Discretionary Review Abbreviated Analysis

Case No.: 2017-000987DRP-04

Project Address: 27 17th Avenue Permit Application: 2018.0625.2842

Recommendation: Take DR and Approve with Modifications

Exhibit 1: Bay window and decks before demolition

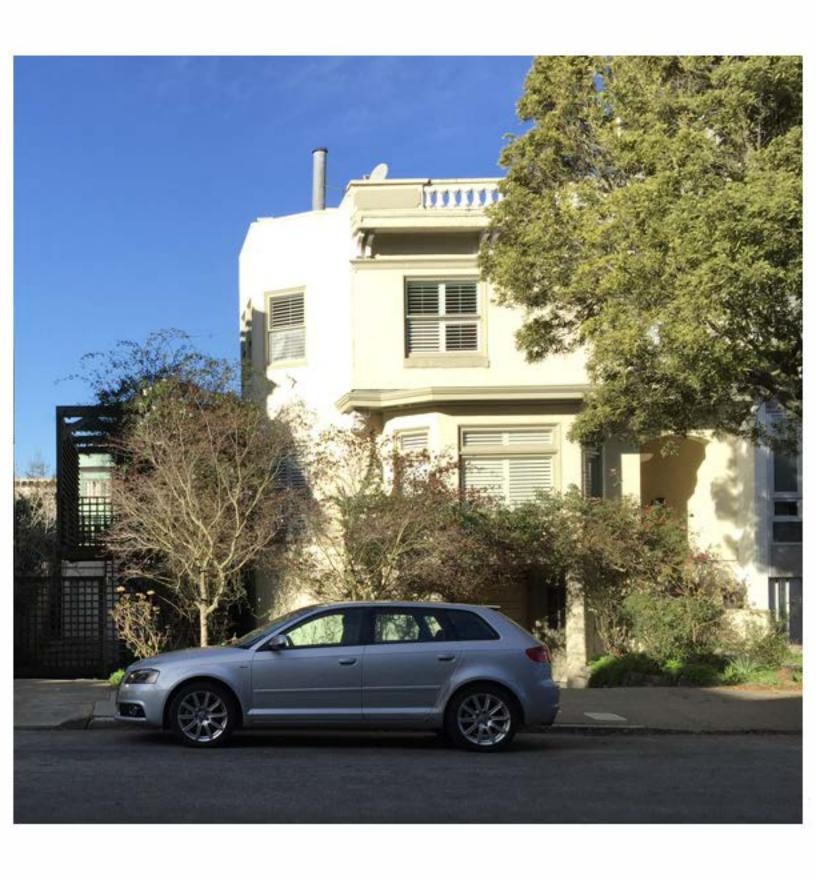
In June 2016, an over the counter permit (BPA No.: 2016.0616.0104) was issued to remove lath and plaster and repair dry rot on the subject property. The actual scope of work included the demolition and removal of two decks, a chimney, and a bay window (Exhibit 1: Image of bay window and decks before unpermitted demolition). The result was a series of complaints, notices of violation, enforcement cases, and an appeal. During this time, with the 'encroaching' bay window, decks and chimney now removed, a lot subdivision was proposed and subsequently deemed compliant in February 2017. Despite common practice that all permit activity be placed on hold for properties with violations, the lot split occurred, and the project sponsor submitted two project proposals – a remodel of the existing property and a new construction on the now vacant lot. During approximately the same time, permits were issued to replace the existing foundation (BPA Nos: 2016.0106.6439, 2016.0701.1417, 2017.0830.6367, 2017.1213.6333), again, notices of violations and corrections and an appeal occurred. The Board of Appeals eliminated the abatement of the bay and deck from the abatement permit and allowed the property owner to continue with a permitted foundation replacement and a voluntary seismic upgrade. The foundation replacement and seismic upgrade have not been completed, the project was abandoned in August of 2018. It is suspected the scope of unpermitted work completed by the sponsor also included the creation of usable floor area at the first floor expanding the home from

ROUGH SKETCH OF NEW HOUSE 17 AVE? STEPHANIE PECK 20 MAY 2016

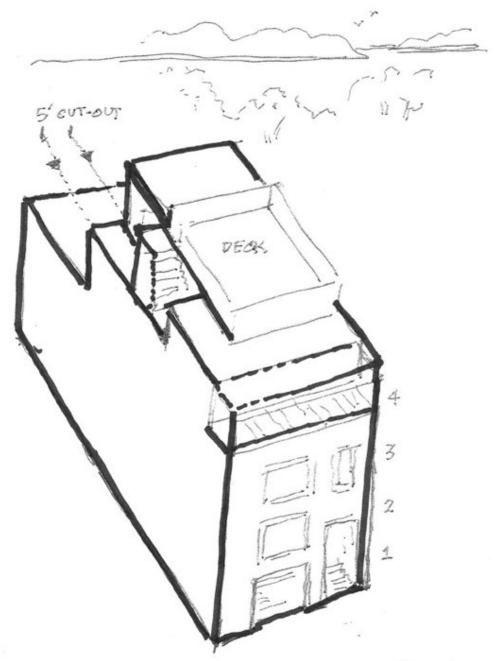
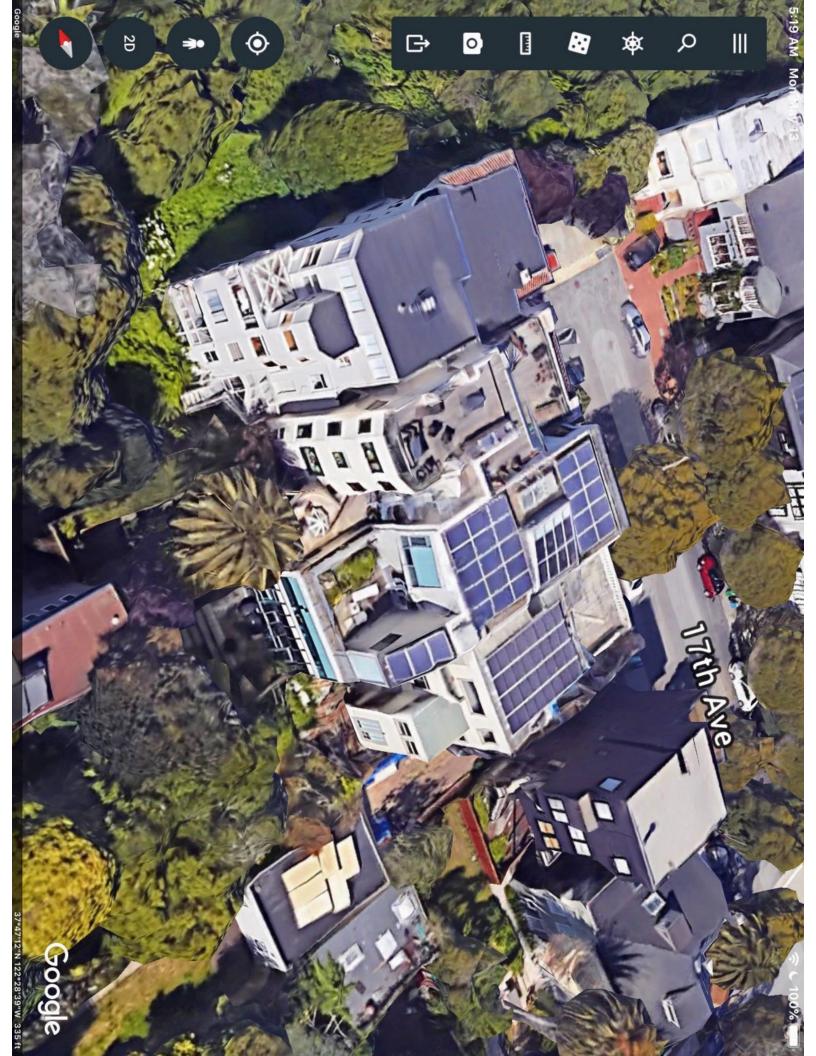
I think there are design steps that can be taken which, while maintaining as much square footage as you need to make a profit on your investment, could minimize negative impacts on my property.

As a working artist, my greatest need is natural light in my studio on my top floor. In order to not lose much north light, a possible solution comes to mind. On the top 4th floor, you might build out to my north awning window and then design an exterior staircase to a possible roof deck. That would provide a cutout so that there is still light coming in my north window. Please see attached sketch I made.
